SERVICE BULLETIN

Service Bulletin No.	SB-ESCAPE214-216_001
Service Bulletin Affected Parts	Fuse box connector
Revision	Rev. 00
Issue date	12 July, 2026
Classification	Mandatory
Aircraft type / model	ESCAPE 214 / ESCAPE 216
Affected serial numbers	003 / 006 / 007 / 008 / 009
Prepared by	Alessandro Berion
Approved by	Roberto Lamanna

Fig. 1.0 — Protection tape on the wiring.

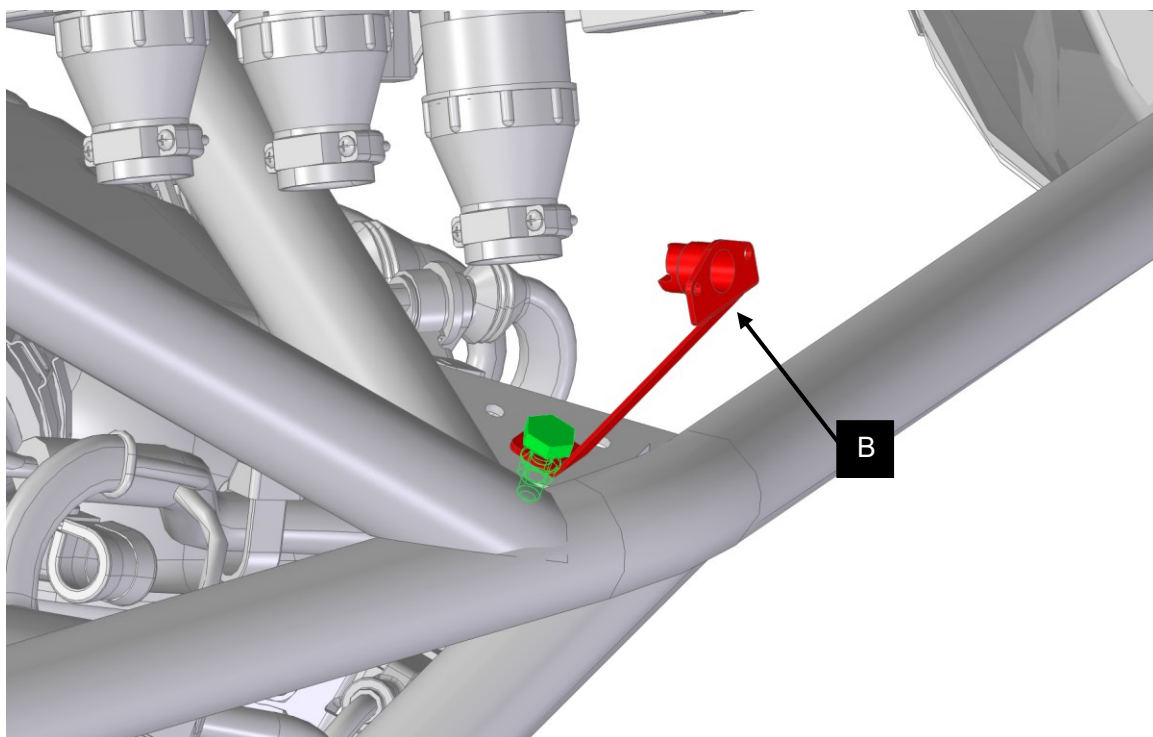
Step	Inspection / criterion	Limit / acceptance
1	With the left cowling closed and secured in its flight configuration, check the clearance between the cowling and the fuse-box input connector wiring, highlighted in FIG.1.0 . Perform the check using a flashlight, looking from the side or from below the cowling.	Minimum 10 mm.
2	Inspect the connector wiring insulation for chafing, abrasion or exposed conductors.	No damage.

Step	Procedure
1	If the measured clearance is 10 mm or greater, wrap the first section of the fuse-box input connector wiring with the protective tape supplied by LAMANNA HELICOPTER. The connector concerned is highlighted in FIG.1.0 .
2	Open the existing hole in the titanium reinforcement plate of the frame using a Ø 4.8 mm drill bit. The hole concerned is highlighted in FIG.4.0 .
3	Install the camlock receptacle (camlock housing) in the hole just opened using the supplied fastening hardware, orienting it so that it is compatible with the cowling in the closed position.
4	Close the left side cowling and bring it to rest against the receptacle just installed; once compatibility is verified, mark on the cowling the exact drilling point.
5	Drill the cowling at the marked point using a Ø 1/4 in (6.35 mm) drill bit.
6	Install the CAMLOCK on the cowling.
7	Close the cowling and check the correct operation of the completed installation.

Fig. 2.0 — Camlock receptacle representation.

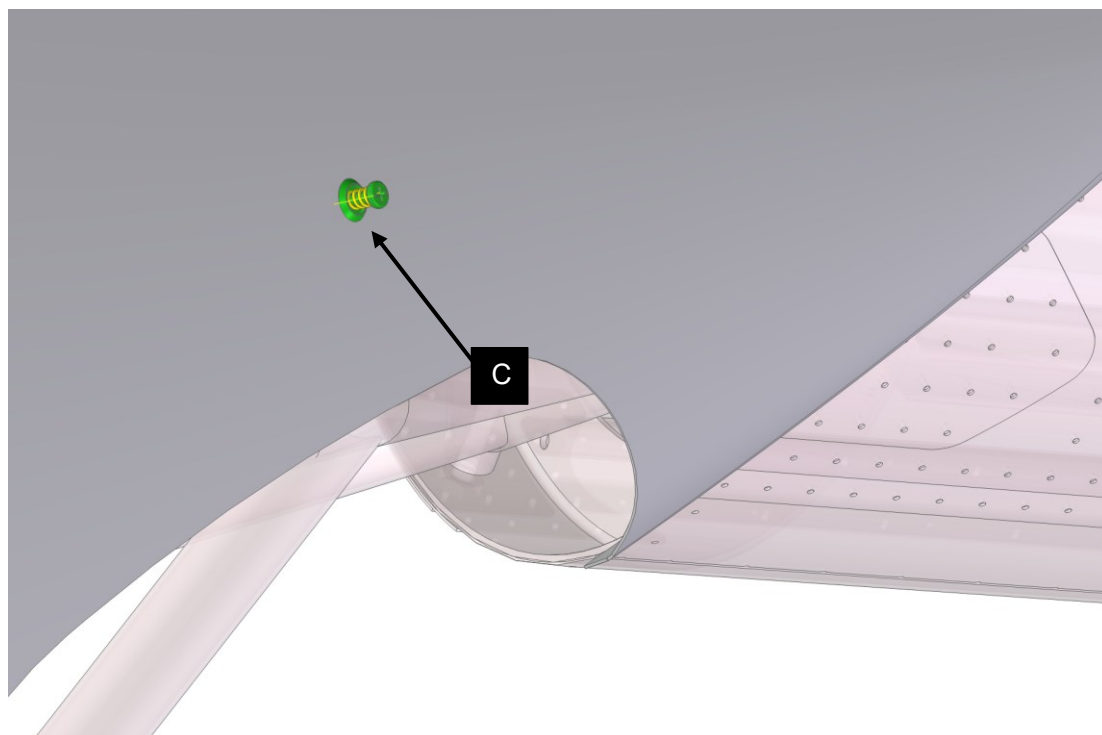
- Enlargement to Ø 4.8 mm of the existing hole in the titanium reinforcement plate of the frame (highlighted in Fig. 4), for the installation of the CAMLOCK receptacle.
- Drilling of the left cowling, hole diameter ¼ in (6.35 mm). The hole position is marked on the cowling with the receptacle installed and the cowling in the closed position, as described in section 3.3.
